AGENDA
CITY PLANNING COMMISSION

Huber Heights Governance Center
6151 Brandt Pike
January 13, 2026
6:00 P.M.

To: Huber Heights City Planning Commission
From: Aaron K. Sorrell, Assistant City Manager
Date: January 8, 2026
Subject: MC 26-01 Dayton Children's Parking Expansion
8501 Old Troy Pike

To: Huber Heights City Planning Commission
From: Aaron K. Sorrell, Assistant City Manager
Date: January 8, 2026
Subject: BDP 26-02 (QuikTrip)
8154 Old Troy Pike

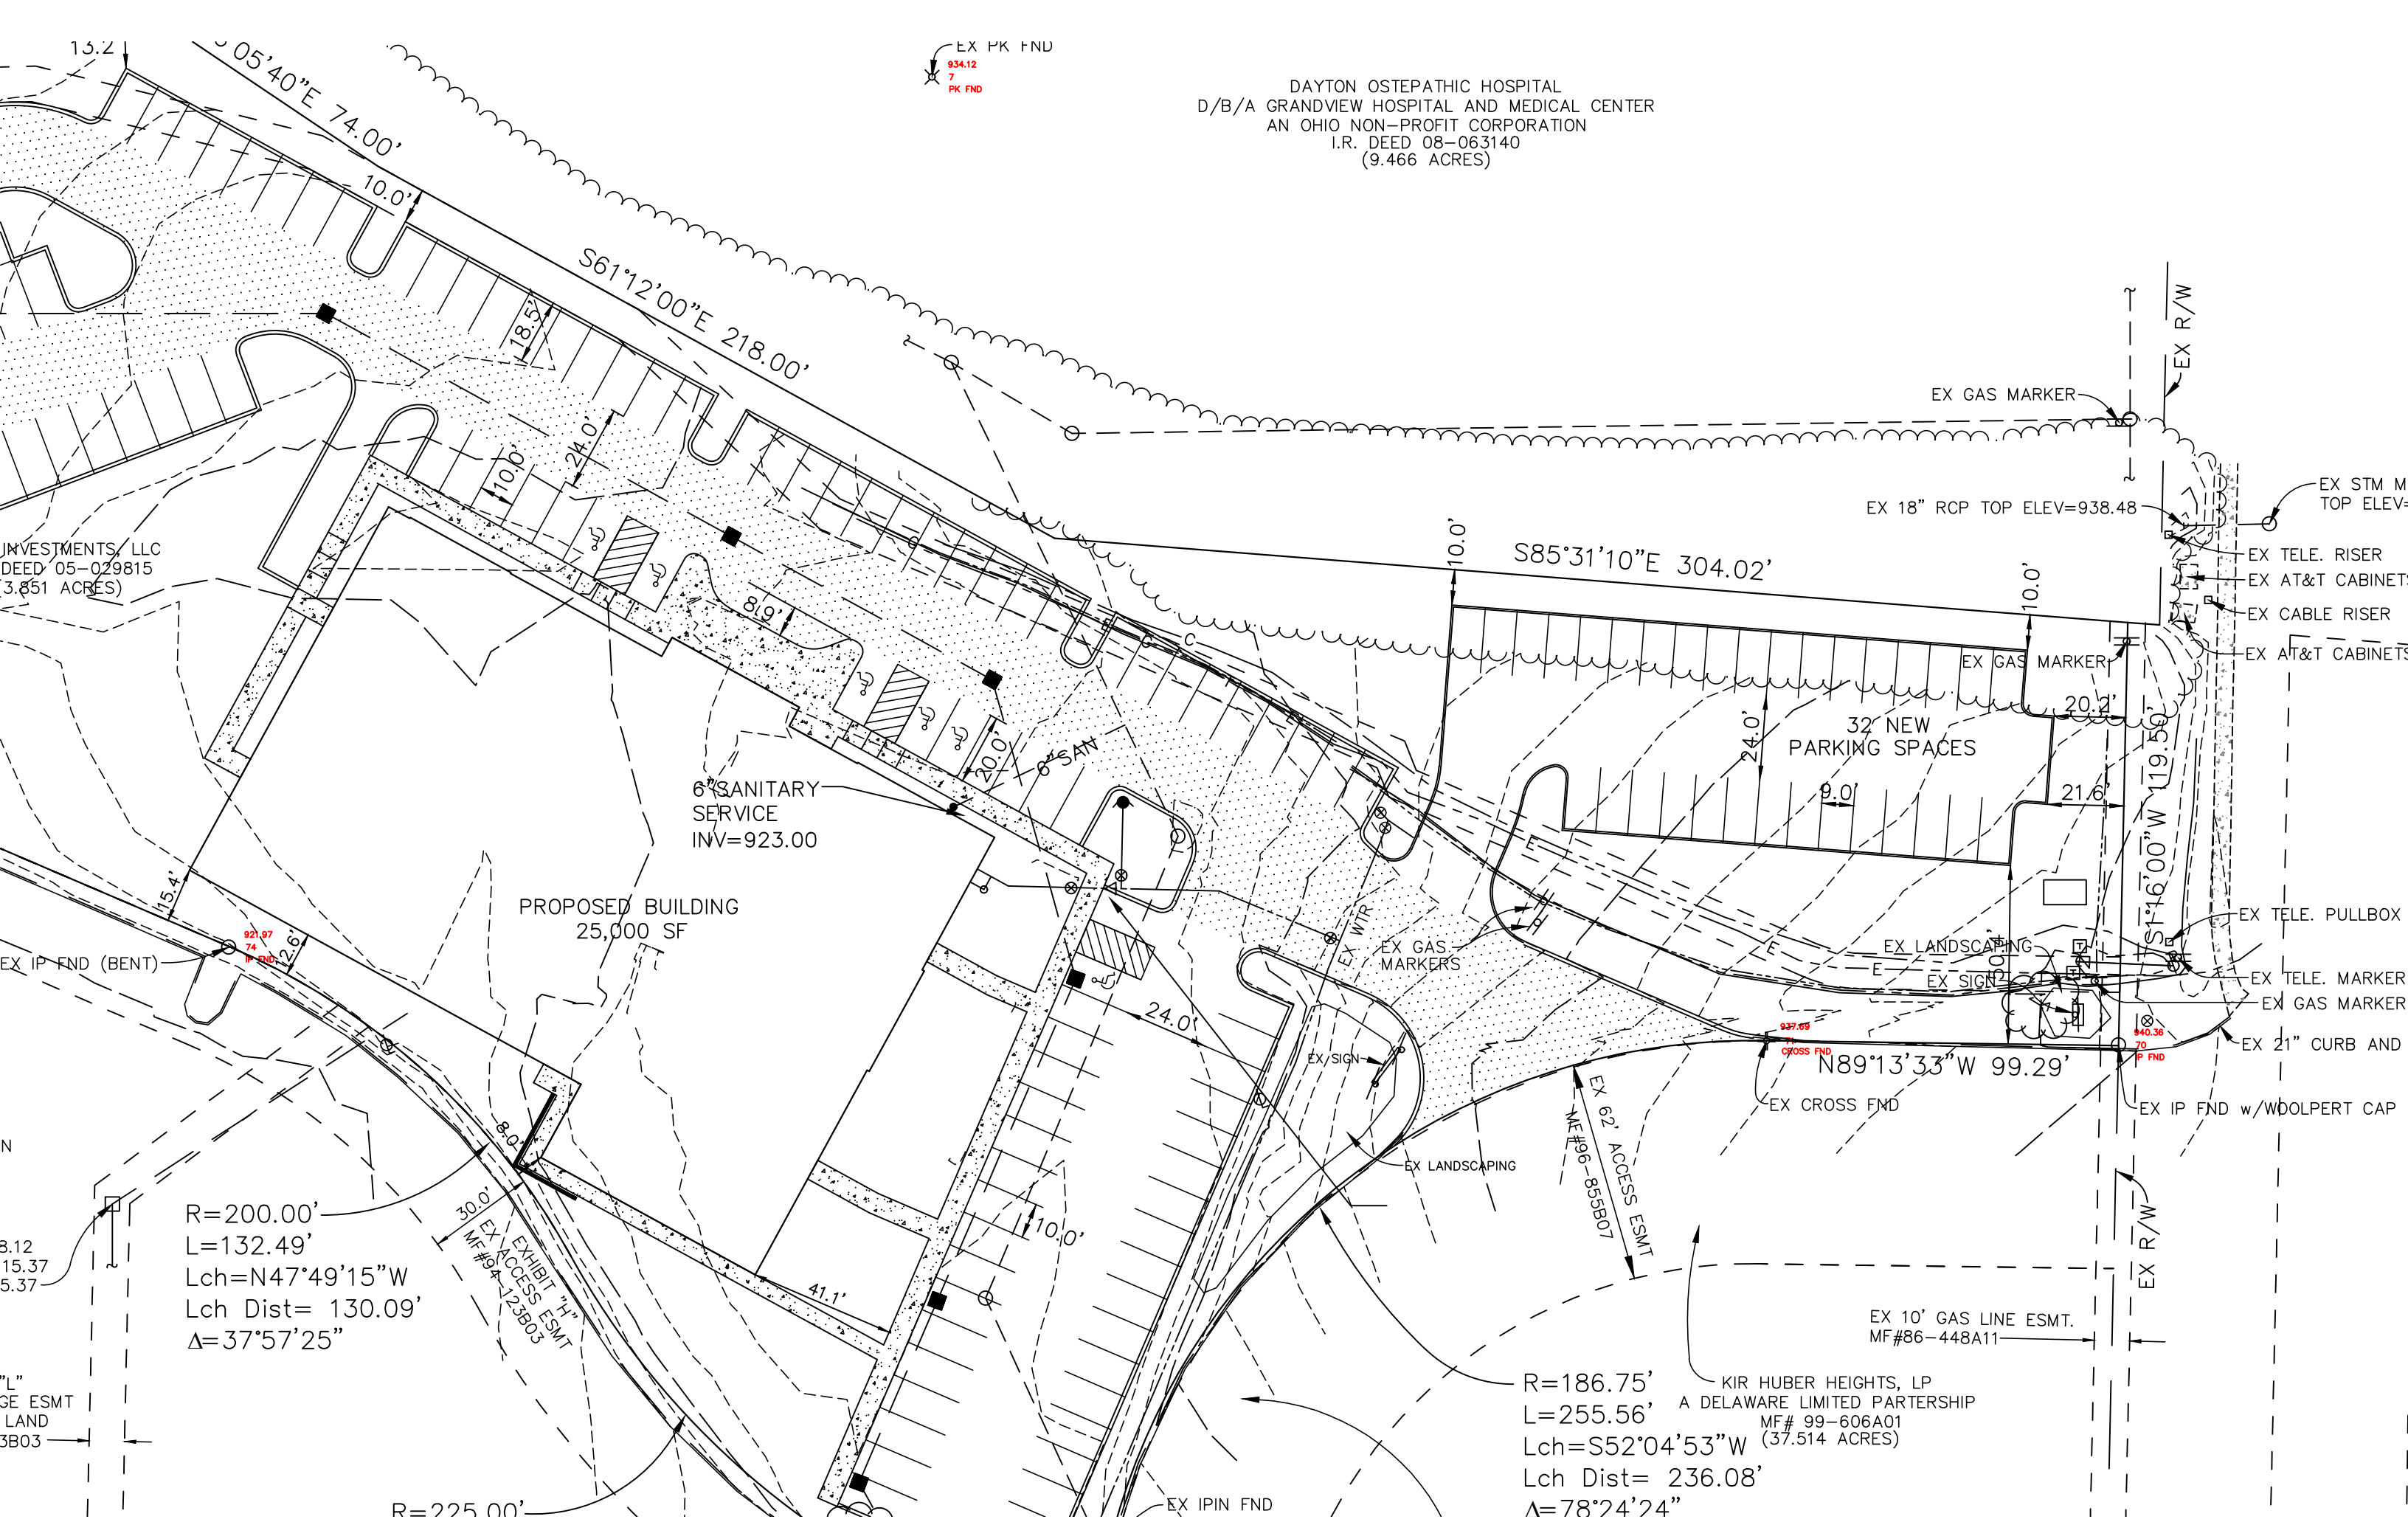
- The site plan illustrates that the parking area is approximately 20 feet from the existing right-of-way. The code requires 25 feet. The proposed parking area is generally aligned with existing parking areas to the south and north. Additionally, the expanded parking area will be set back approximately 45 feet from the back of the sidewalk. Staff feels the proposed parking setback is contextually appropriate with the surrounding area.
- All utilities are below ground.

- No comments. Turn radius appears to meet Huber Heights Fire Division requirements. Any changes to approved drawing would require a new review.

Planning staff supports the minor expansion of the parking areas as submitted and recommends approval with no conditions.

SITE/DEMO PLAN

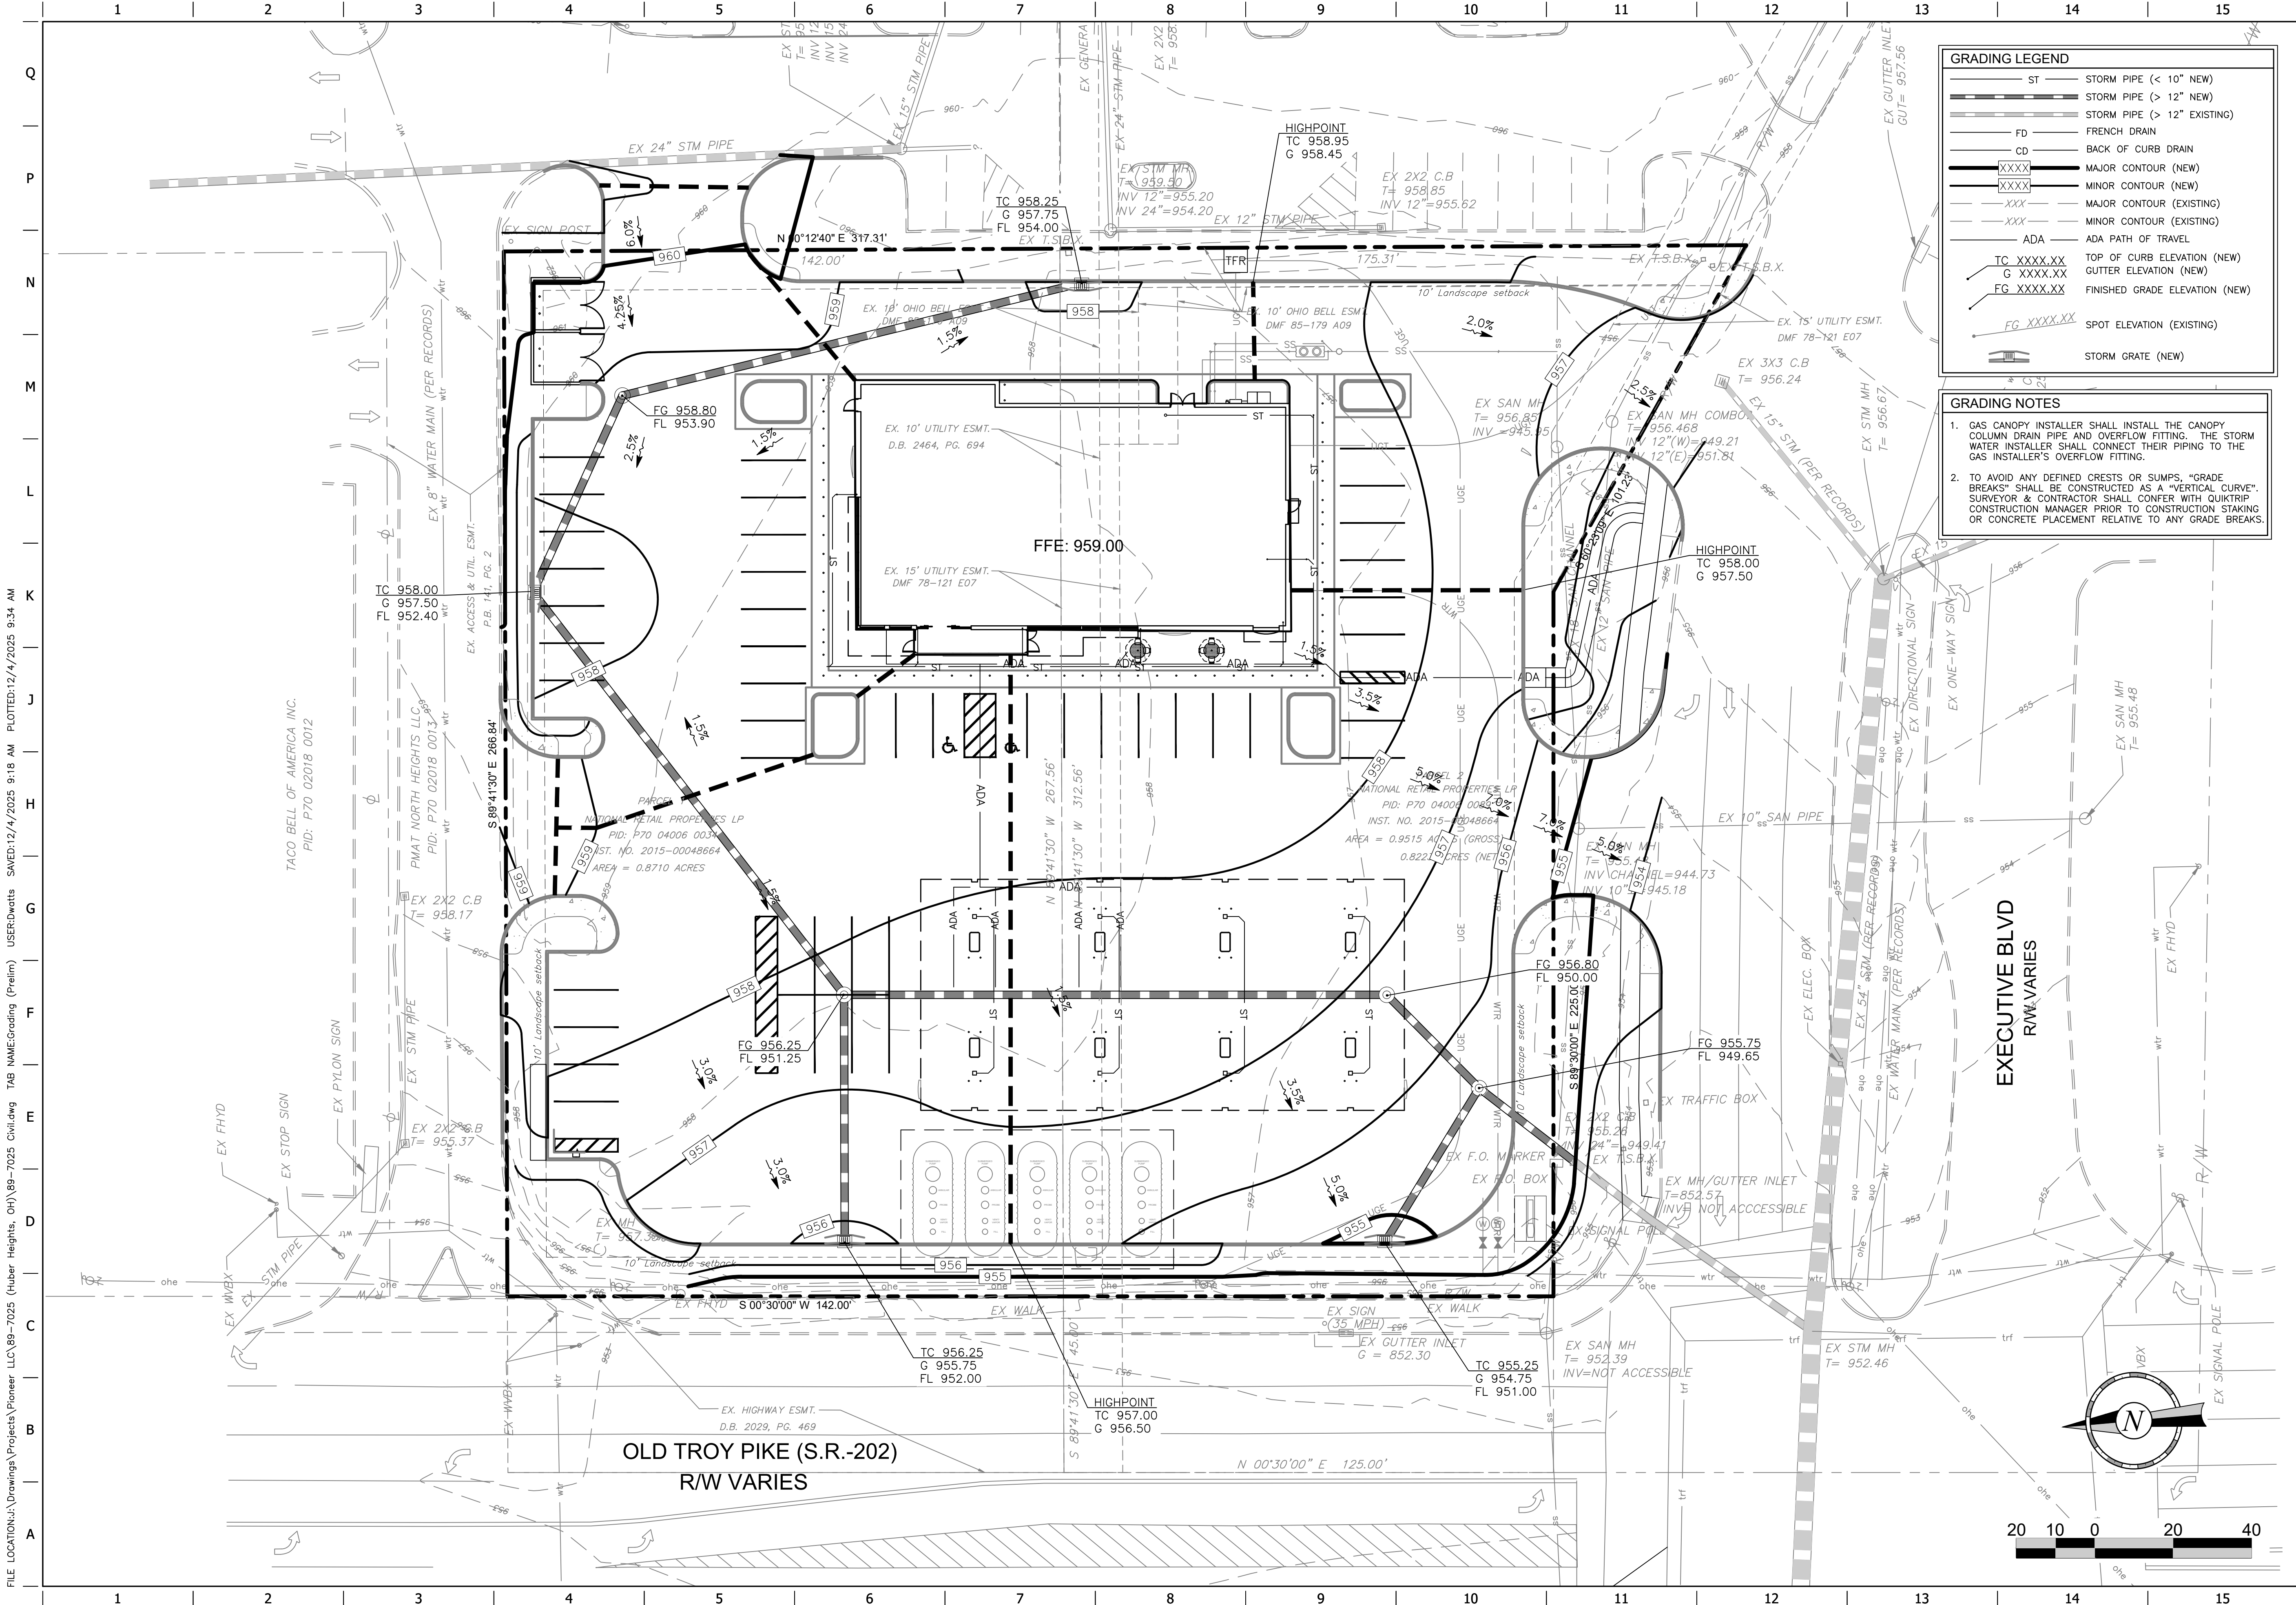
- The zoning code requires a 25-foot parking setback. The site plan illustrates parking along the north property line and adjacent to the building and six spots north of the fueling center. All parking spaces are setback beyond the 25-foot requirement and meet this standard.

- The site plan illustrates 48 parking spaces, not including pump locations. The code requires 1 space per 125 square feet of floor area for a convenience store. Based on this ratio, 52 spaces are required. Most parking stall dimensions are 9.5' x 18'. The code minimum is a parking stall that is at least 10' x 18'. Increasing the stall width will result in three to four fewer parking spaces.

Staff is concerned about congestion on Executive Boulevard if the curb cuts remain as illustrated on the site plan. It is staff's recommendation the west curb cut on Executive Boulevard be removed.

1. Remove the western curb cut.

SHEET TITLE:
LANDSCAPE PLAN (PRELIM)

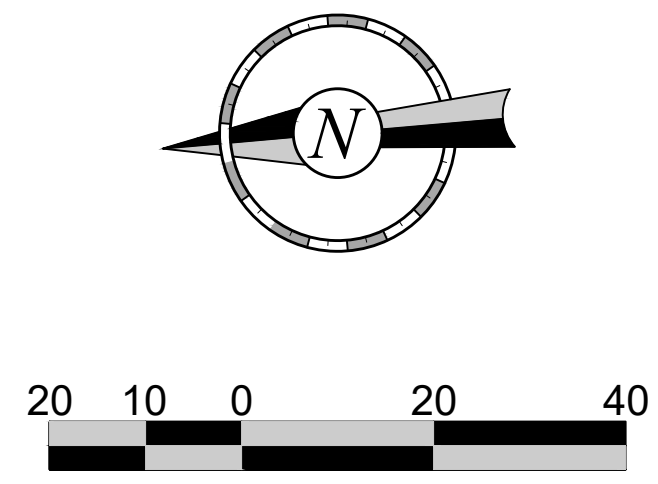
- The preliminary landscaping plan appears to meet the code requirements for both interior and perimeter landscaping. The applicant is providing shade trees along the perimeter (except Old Troy Pike), along with a significant number of shrubs and perennials.
- There is an overhead utility line easement along Old Troy Pike. Therefore, the applicant is proposing a mixture of dwarf crabapple trees and boxwood hedges. The proposed landscaping along Old Troy Pike is appropriate given the presence of overhead utility lines.
